Project Name/Address: 104 E Gilman, Kendall House

Application Type: Certificate of Appropriateness for exterior alteration on a landmark site and in a historic district

Prepared By: Amy L. Scanlon, Preservation Planner, Planning Division

Date Prepared: July 16, 2018

Photo from the 1970s

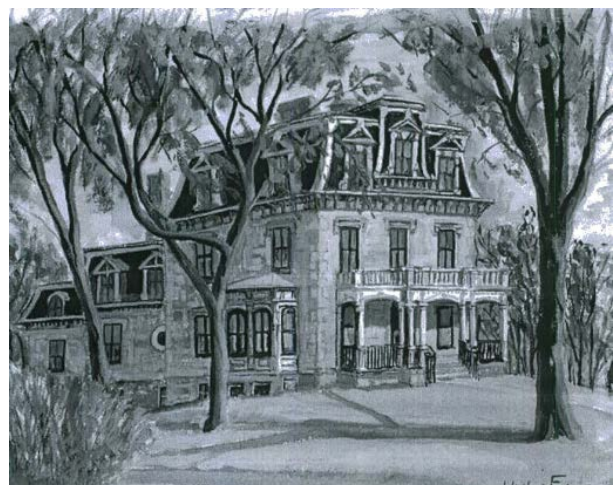
The work was constructed differently than approved. The piers were constructed in brick instead of wood and the brick was not in a color that was appropriate for the landmark building. The two middle piers flanking the front steps were constructed wider and taller than the other piers. In addition, the middle piers have been installed with conduit and wiring to receive a top mounted light fixture. Staff worked with the property owner's representative to find an agreeable solution to allow the brick piers to remain. The brick has been stained to closely match the color of the stone. In their current configuration, the piers are very similar to those shown in the photo from the 1970s except that the middle piers are wider and taller than the other piers.

Documentary evidence of the piers does not seem to be available so it is unknown if the original piers for the covered porch were brick or stone or wood. It may be possible that the piers shown in the photo from the 1970s are original to the construction of the covered porch. The original building did not have a mansard roof or a

1. The caps of the piers that have been drilled for light fixtures shall be covered or replaced so that wiring cannot be accessed for the installation of light fixtures. It would be more appropriate to add light fixtures directed toward the stairs in a lower portion of the pier. Any light fixture installation would need the review and approval of the Landmarks Commission. If the caps are replaced, they should have a pyramidal sloped top surface instead of being flat. In addition, the overhang should be reduced so that the cap is more appropriately sized to the pier.
2. The middle piers shall be reduced in height so that they match the height of the other piers.
